WESTPOINTE WEST OFF-SITE SEWER
EXTENSION PHASE 2
SAWS Job No. 18-1674
SAWS Solicitation No. CO-00329

ADDENDUM NO. 2
March 25, 2020

PLAT NO. N/A
 JOB NO. 11581-01
 DATE AUGUST 2018
 DESIGNER RG
 CHECKED RG DRAWN EP
 SHEET C2.01

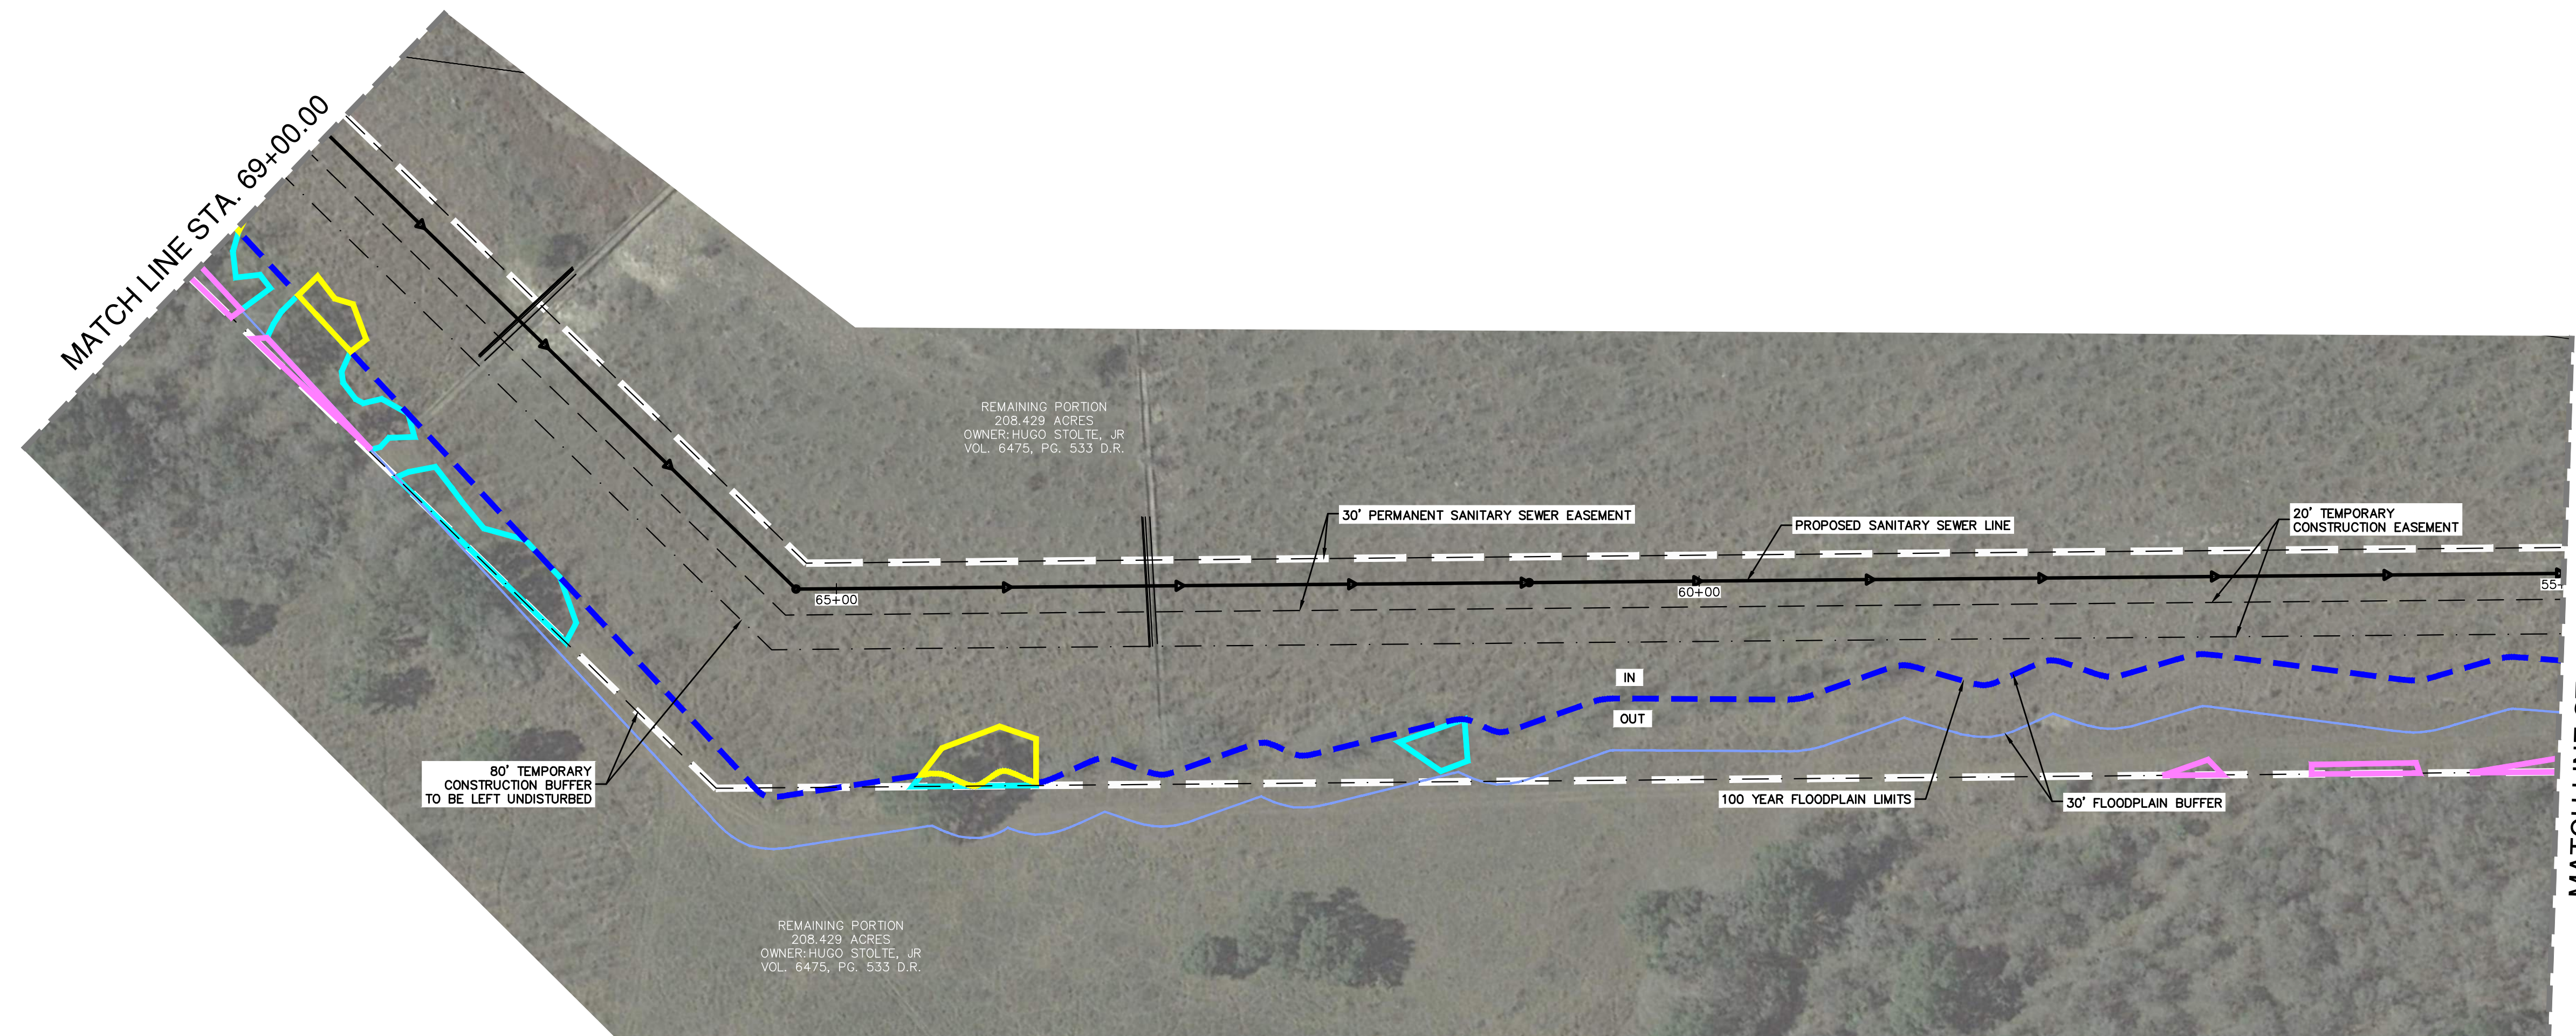
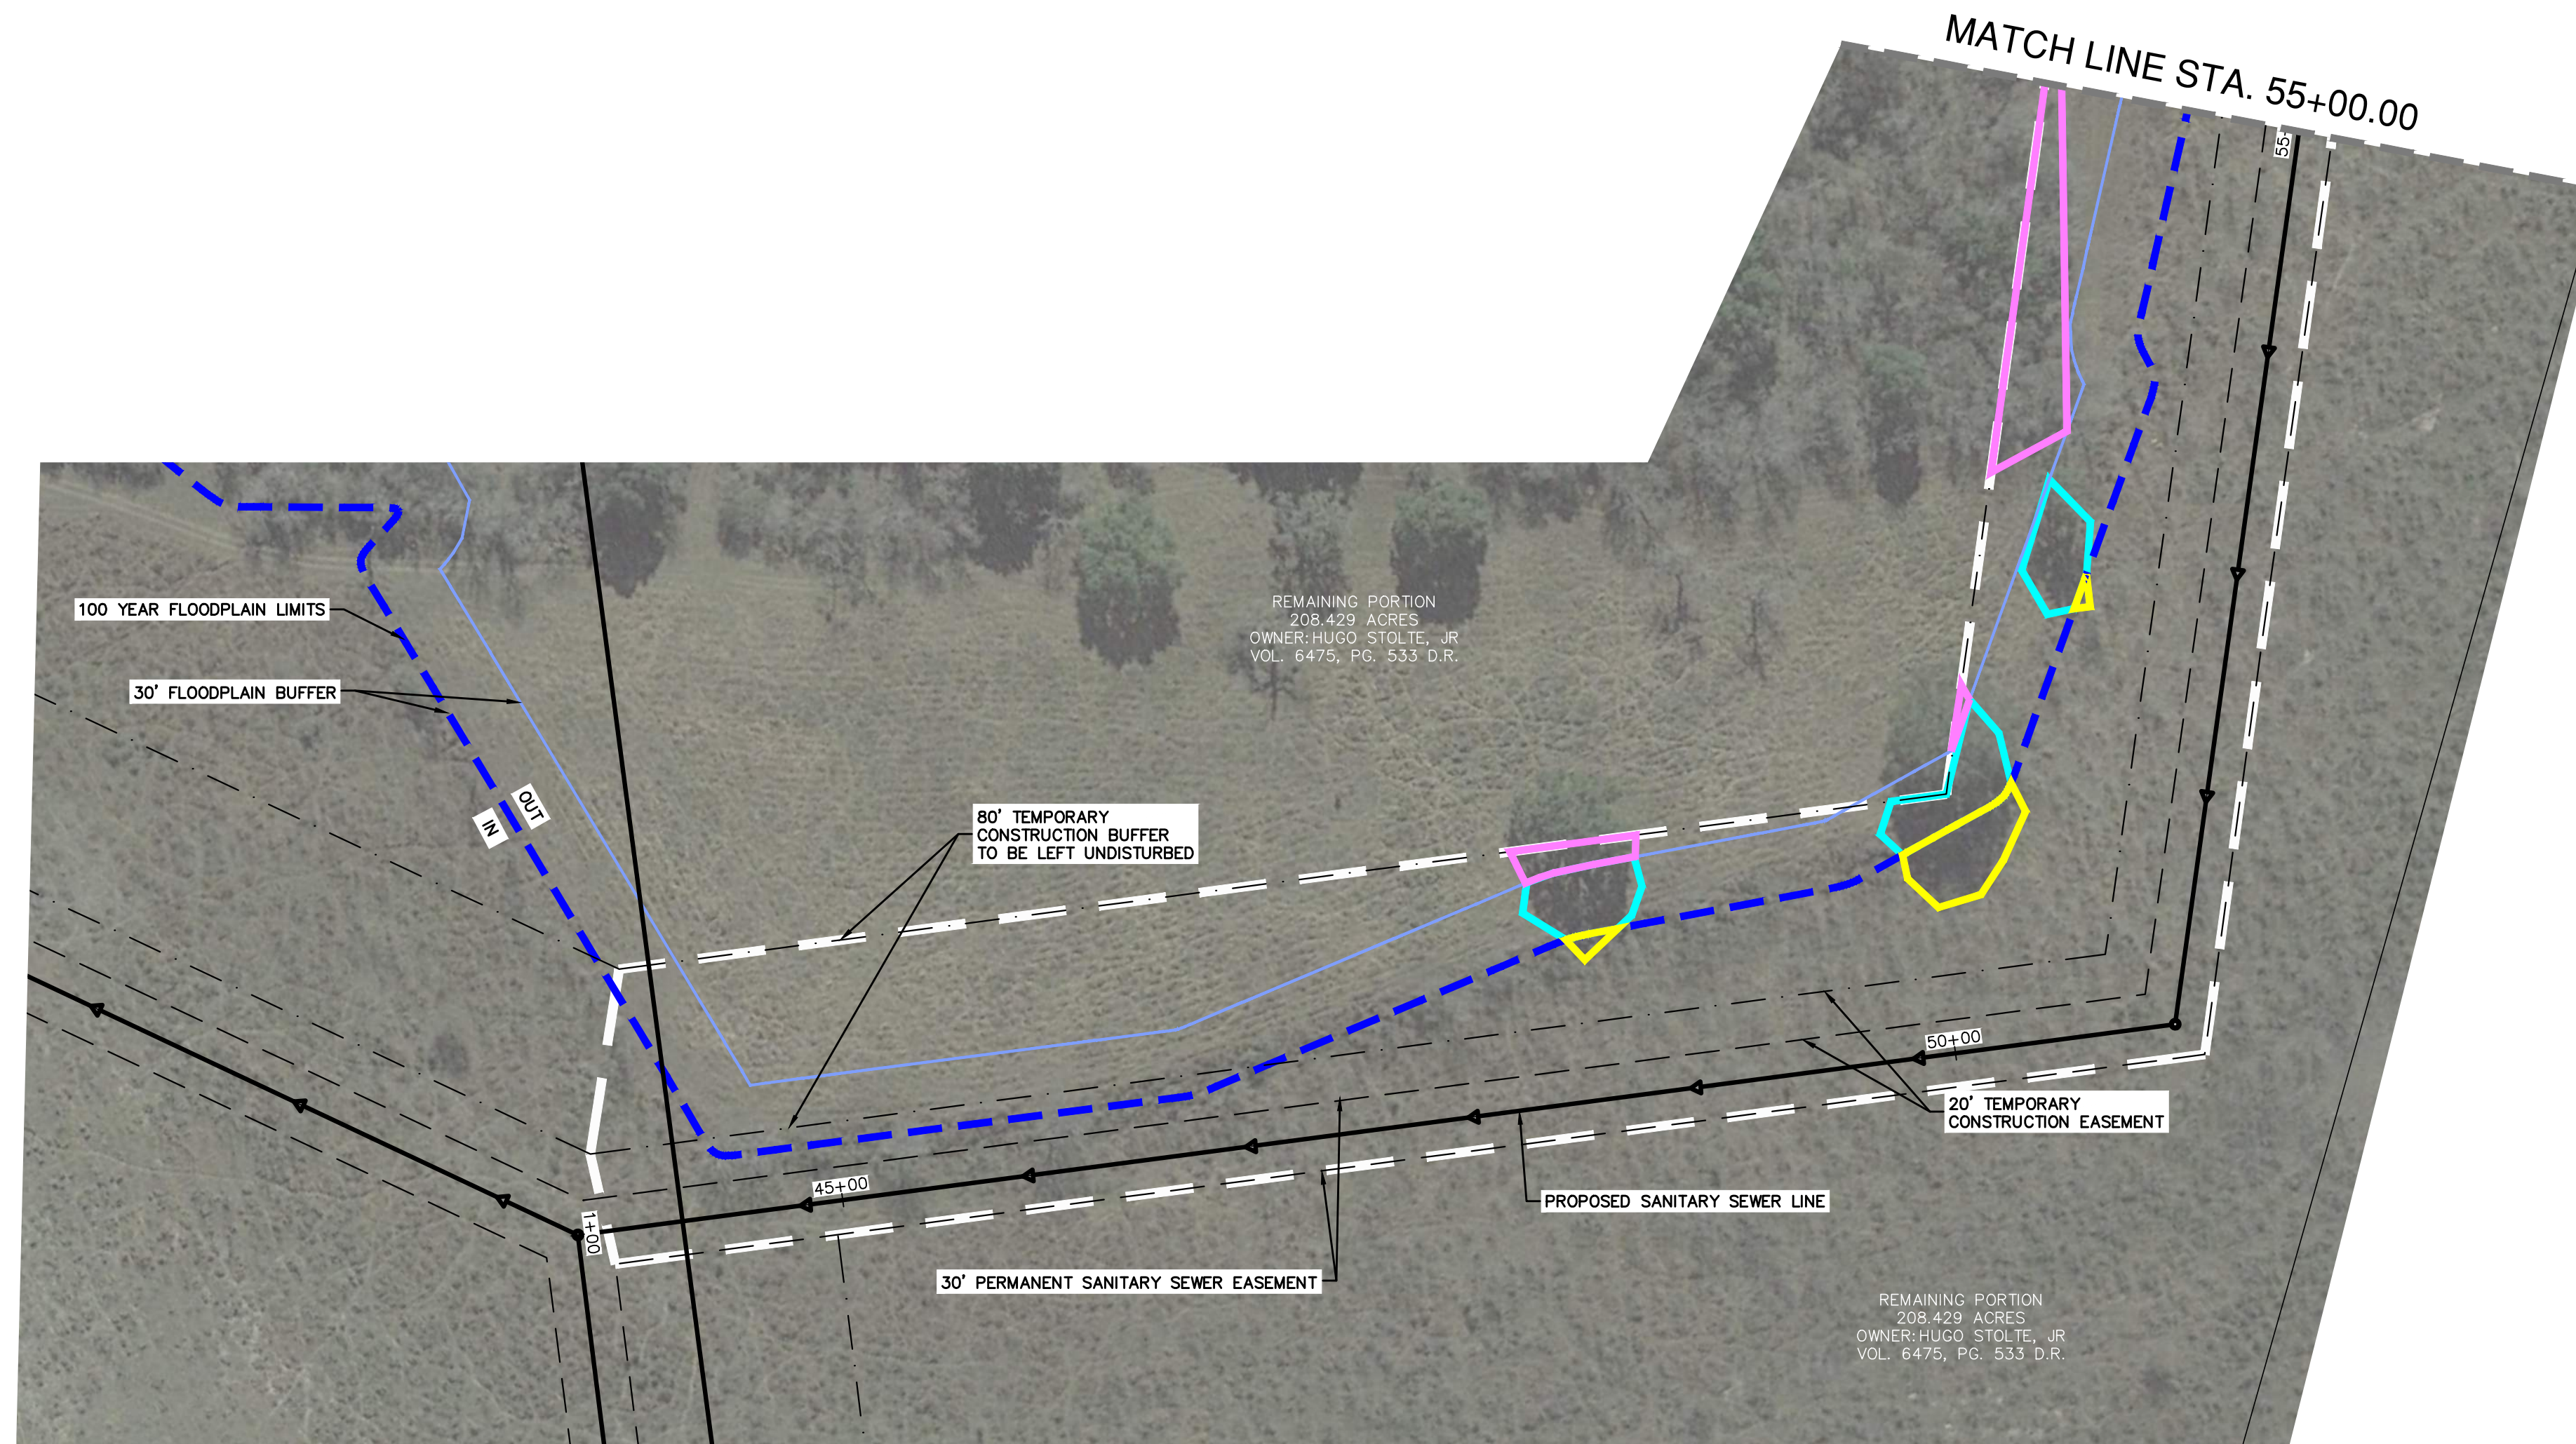
QUESTION 11: Sheets C2.00 and C2.01 do not appear to have plotted correctly from the CAD file. Can you please reissue these two sheets?

RESPONSE: The design team has reviewed the plan sheets and they all appear to have plotted correctly. A copy of Sheets C2.00 and C2.01 are included with this addendum.
